CITY OF ALBUQUERQUE

**RE: National Electric, 2200 Midtown Plaza NE
Grading and Drainage Plan
Engineer's Stamp Dated 5-06-15 (File: G16-D095E)**

GRADING AND DRAINAGE PLAN

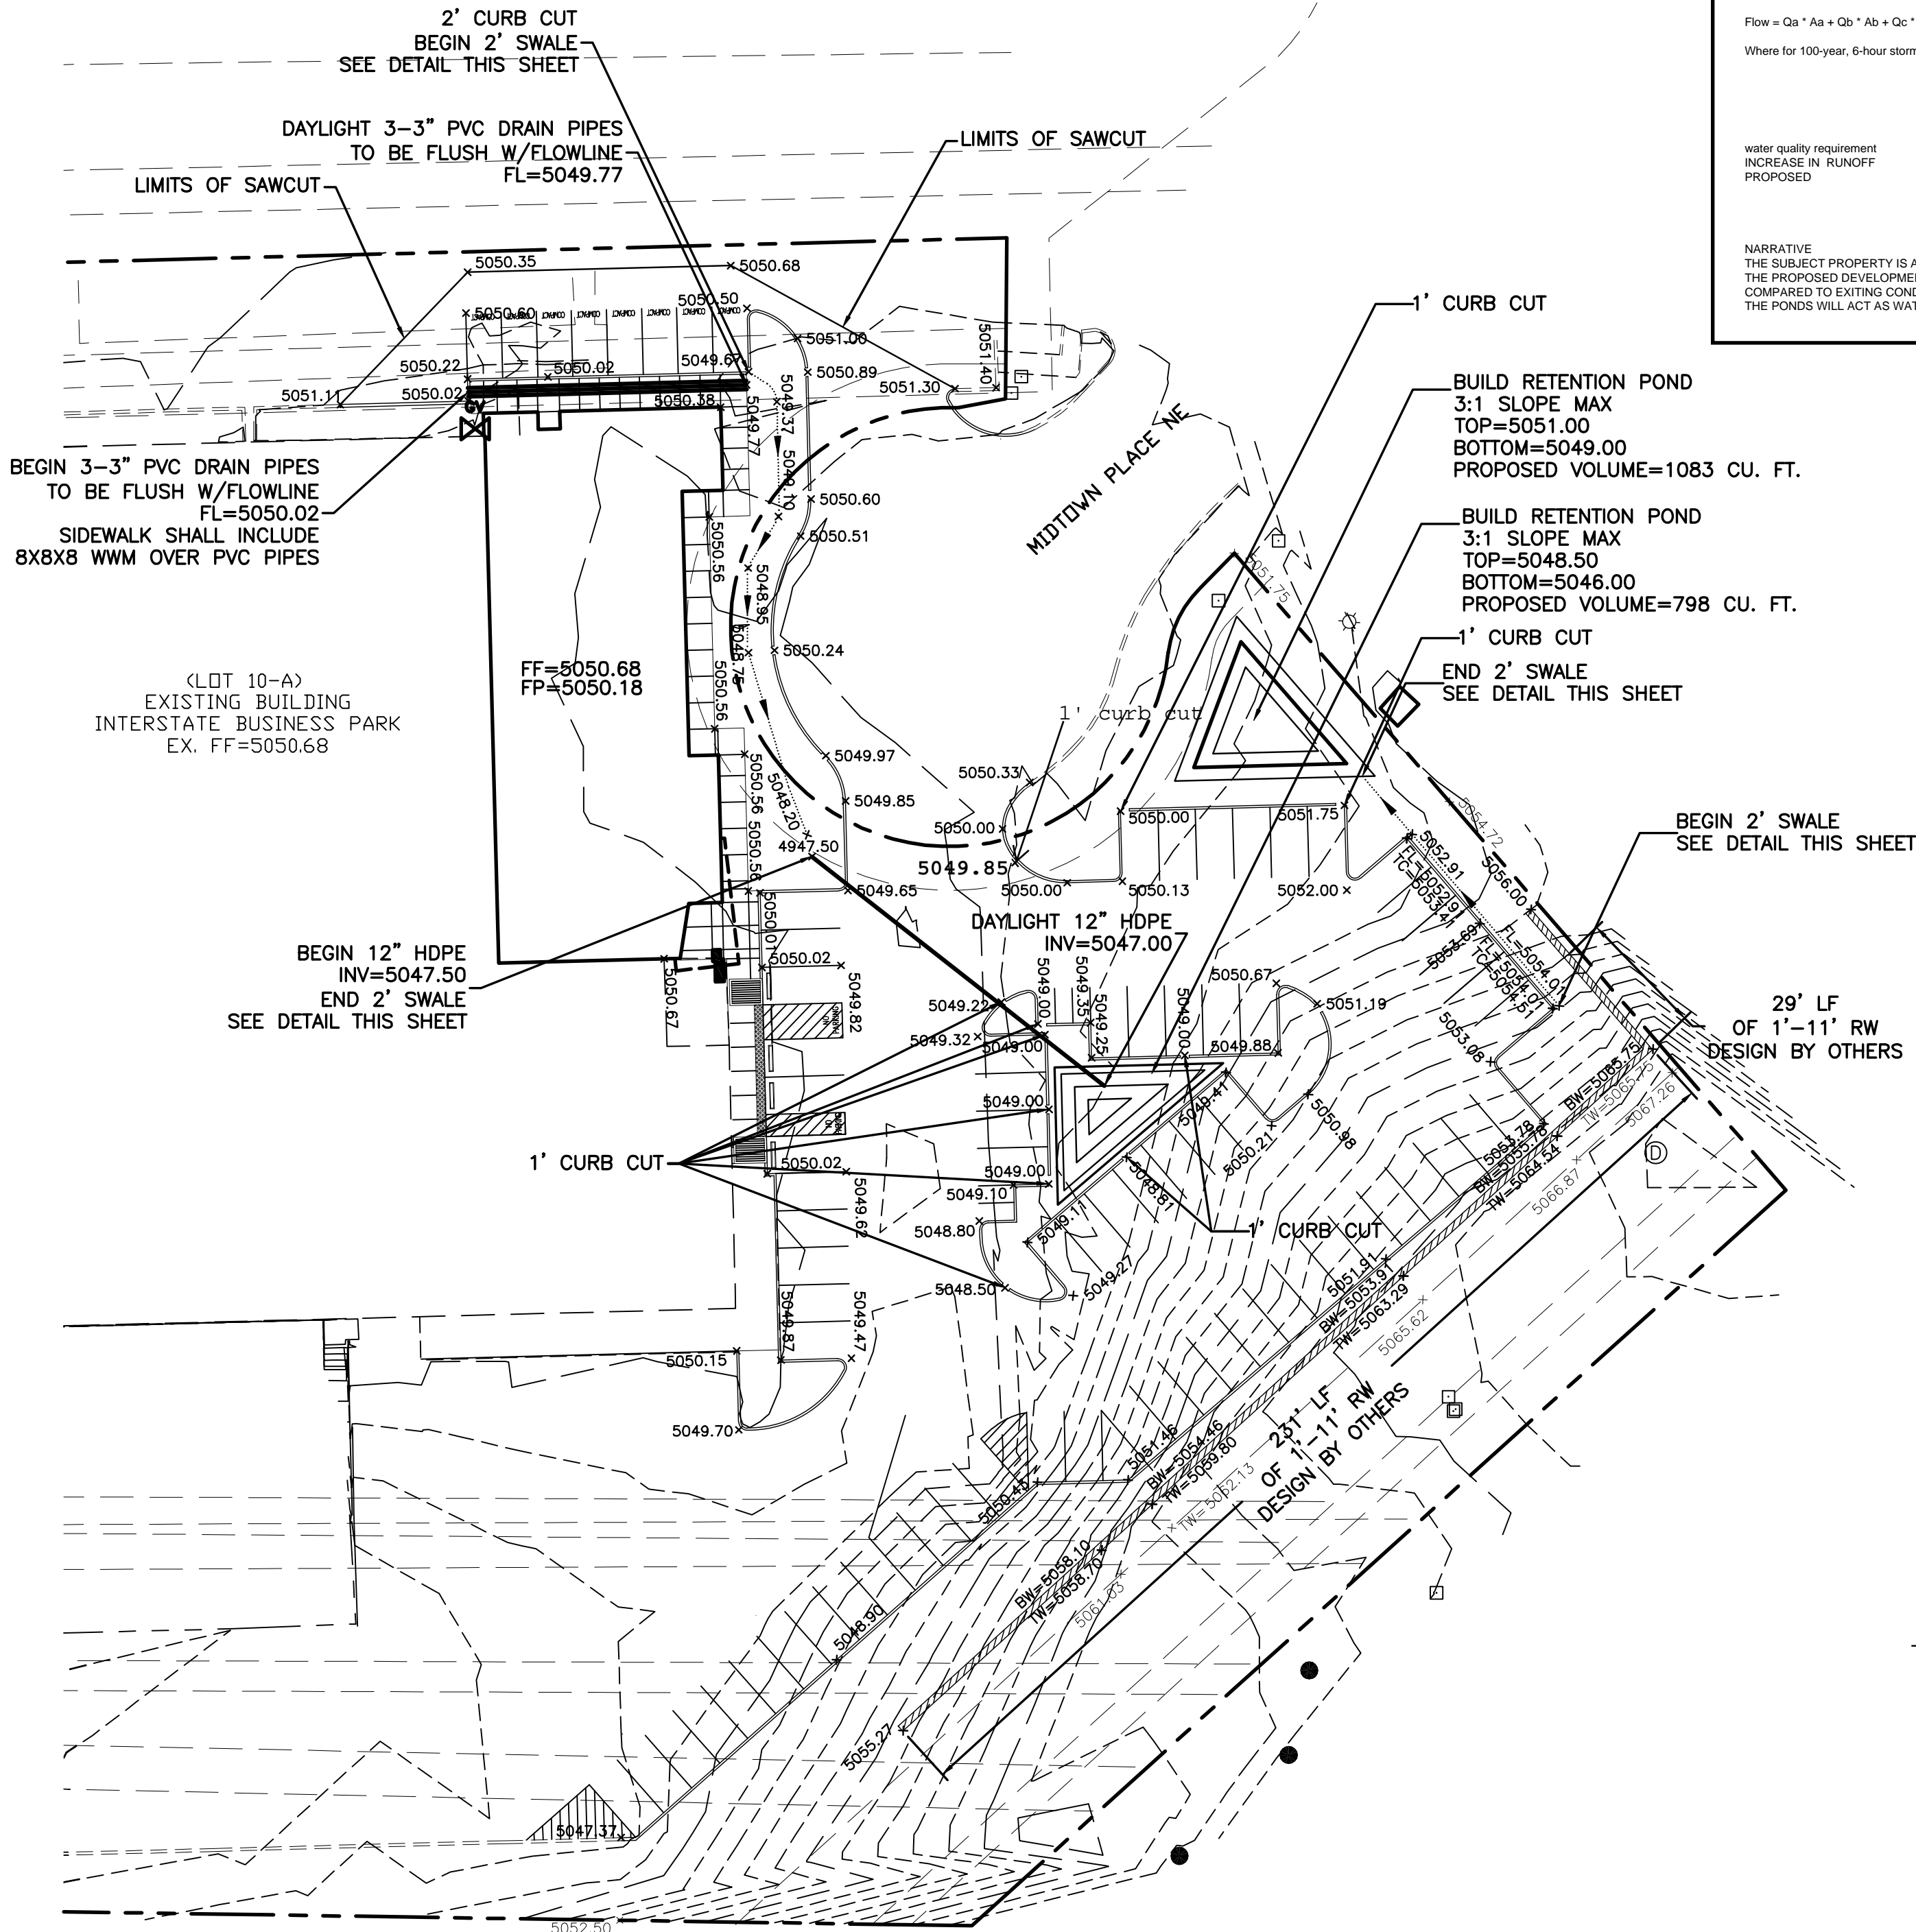
- 1) Show basin boundaries for the provided basin computations, and show where new improvements end and tie into existing facilities.
- 2) Label existing contours and the new contours for the ponds.
- 3) Show swale from 5049.85 spot elevation at entryway to the pond on the north side of the site.
- 4) Show existing and new roof drains.
- 5) In the "Drainage Narrative", mention overall acreage of the site, and explain that historical flow patterns for the site remain the same if this is the case. Discuss the off-site flows from Midtown Place that the site is accepting, and reference the prior drainage report. Mention that the new retention ponds retain the volume of increased runoff from existing conditions.
- 6) Label 100-year storm flow that each of the new on-site pipes is conveying and the pipe slope. Demonstrate capacities.
